# Camelback PUD

C814-86-023.01

Atha Phillips, Environmental Program Coordinator  
Watershed Protection Department

## Critical Water Quality Zone and Crossings

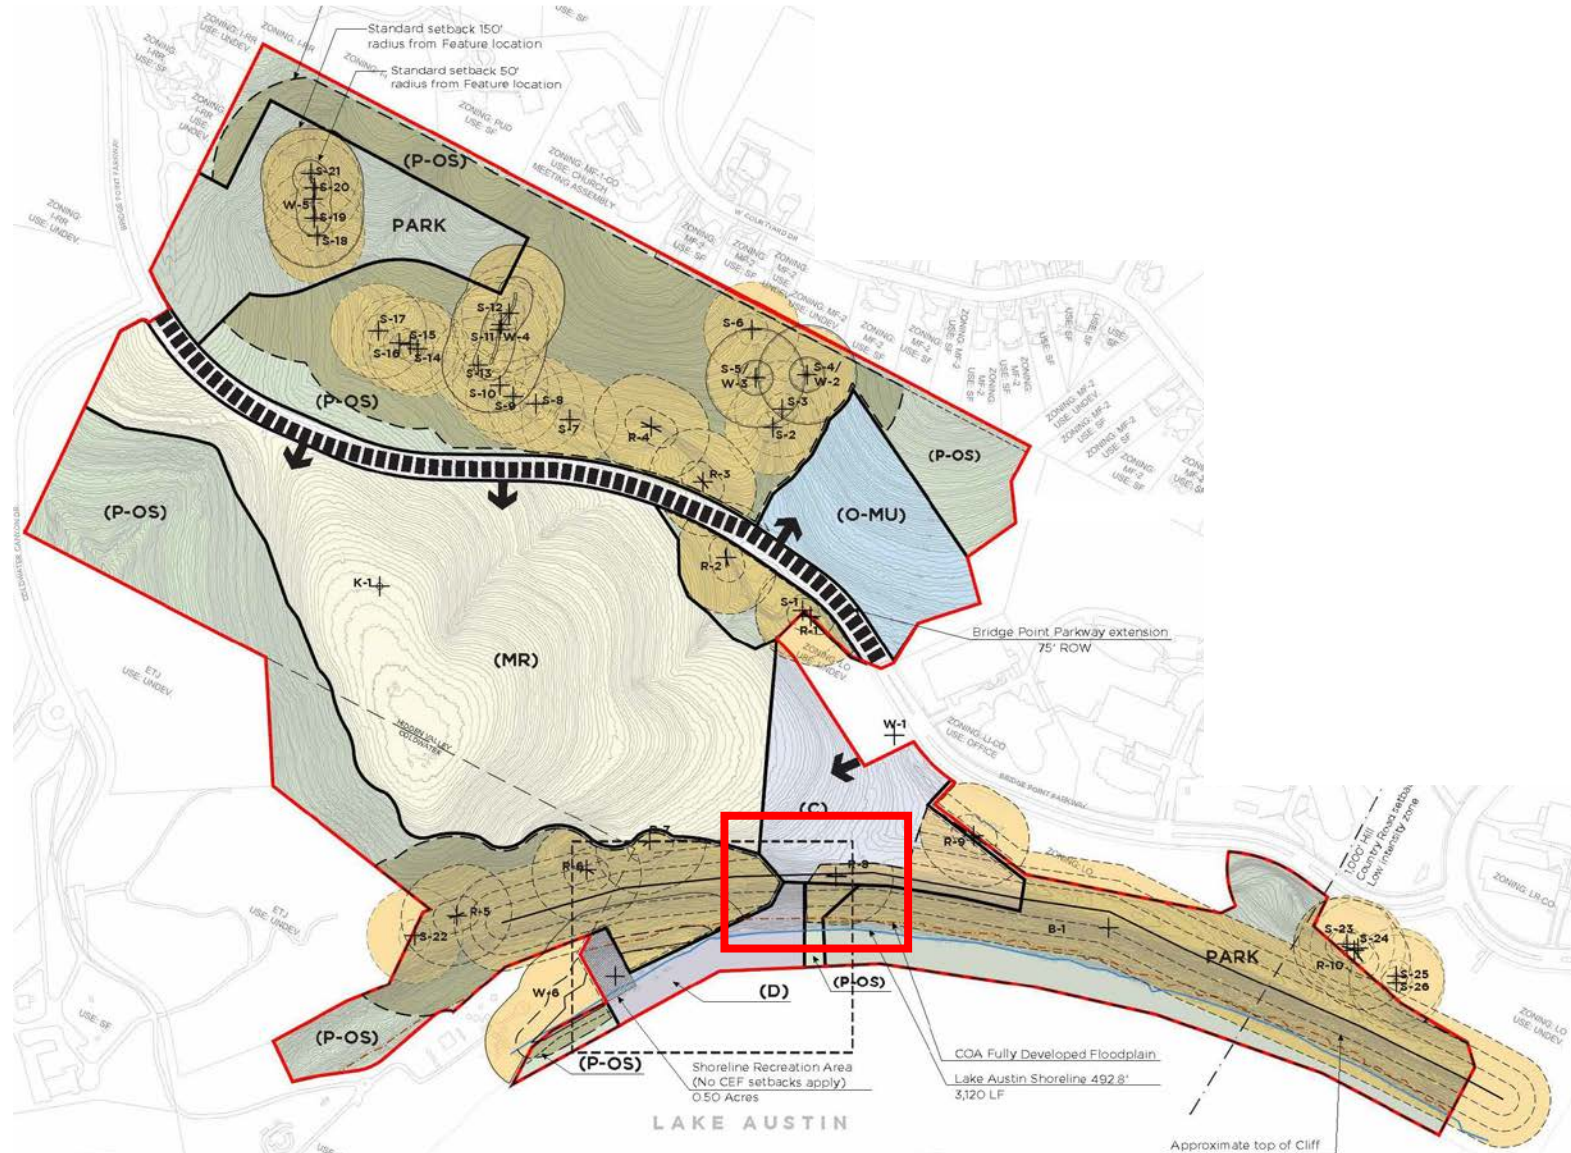
Existing Code	Existing PUD	Proposed PUD	
Current code for CWQZ buffers and 1 variance required for crossing CWQZ buffer	No creek buffers	Proposes 2 crossings 1-Bridgepoint Pkwy 1-(C) Lot access Will span the 10 year high water mark	✓

# Proposed PUD: Heritage Trees

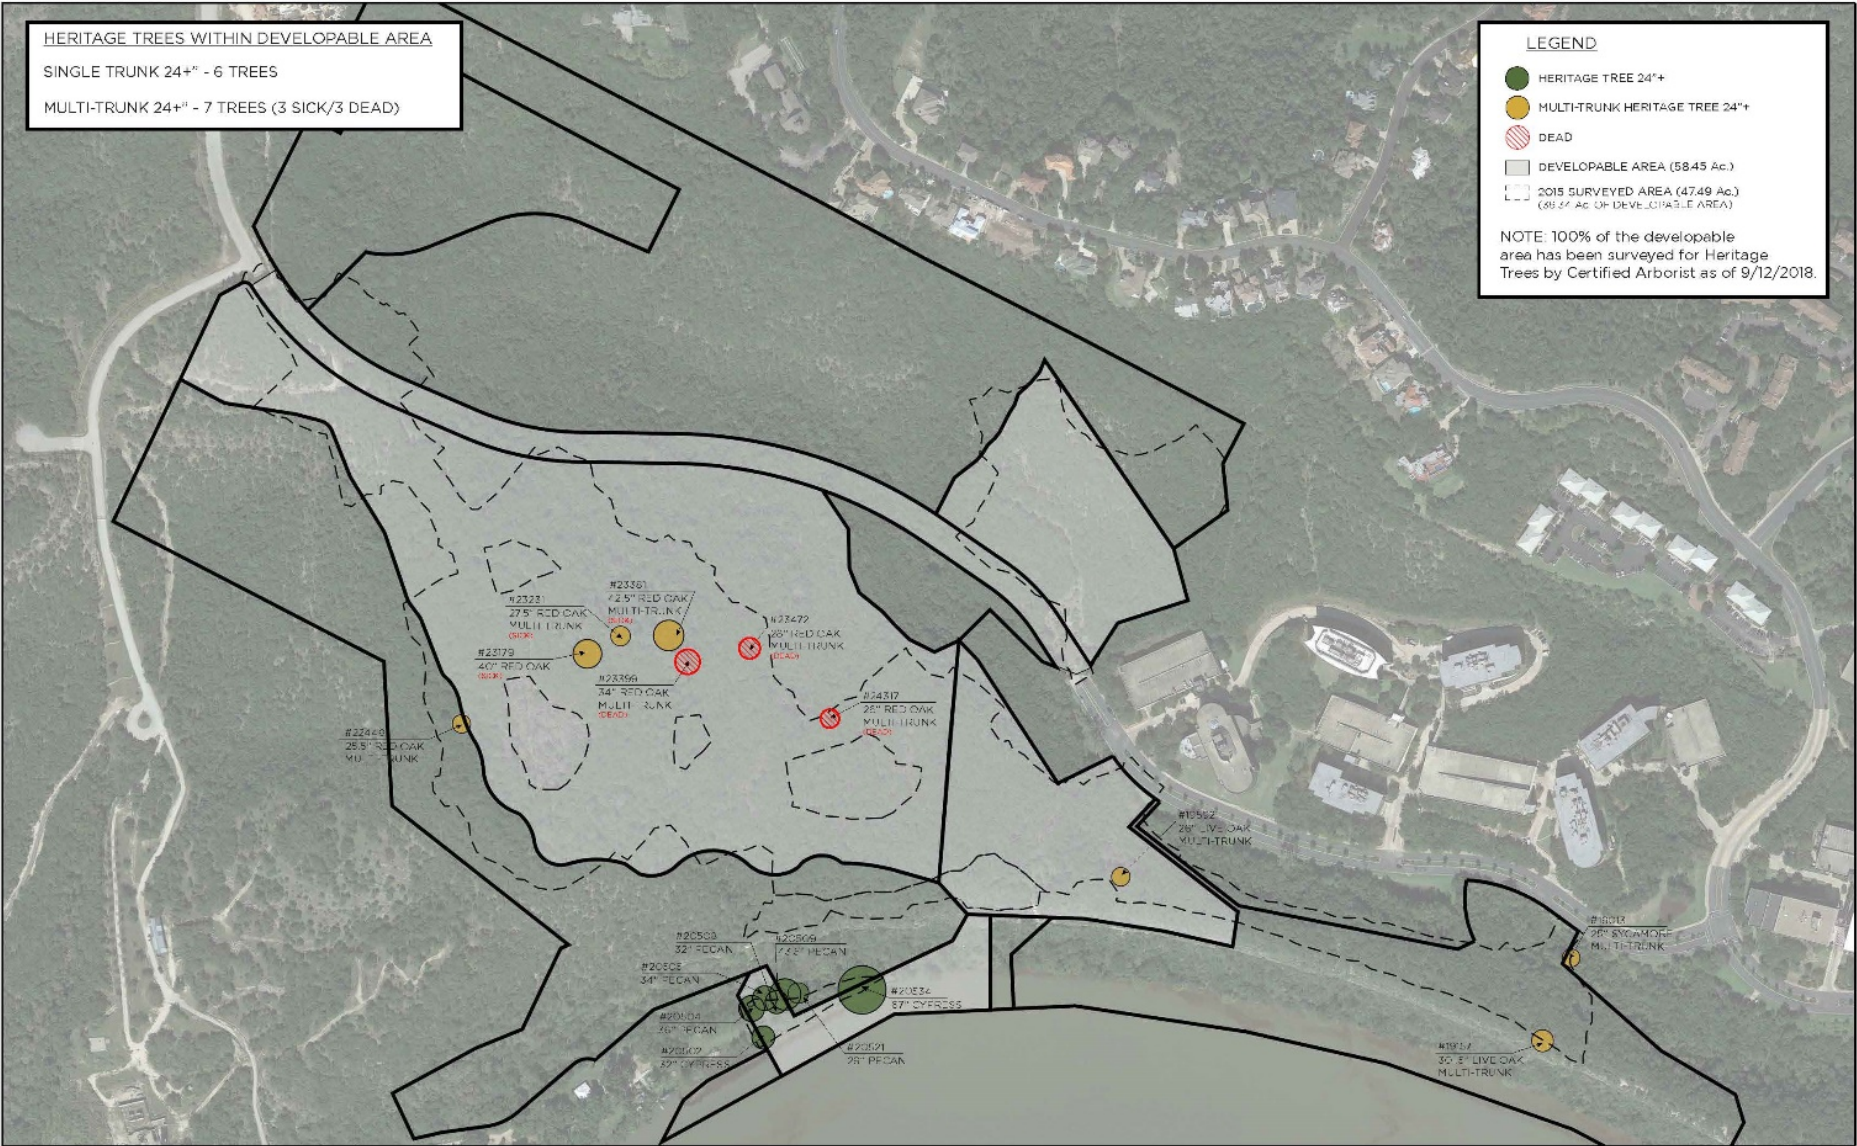
Existing Code	Existing PUD	Proposed PUD
Current Code	Protect trees greater than 19"	Current code except administrative removal of heritage trees identified as dead or diseased. Specifically Trees #: 23179, 23231, 23381*, 23399, 23472*, 24317*

\*Tree health to be verified before PUD goes to Planning Commission
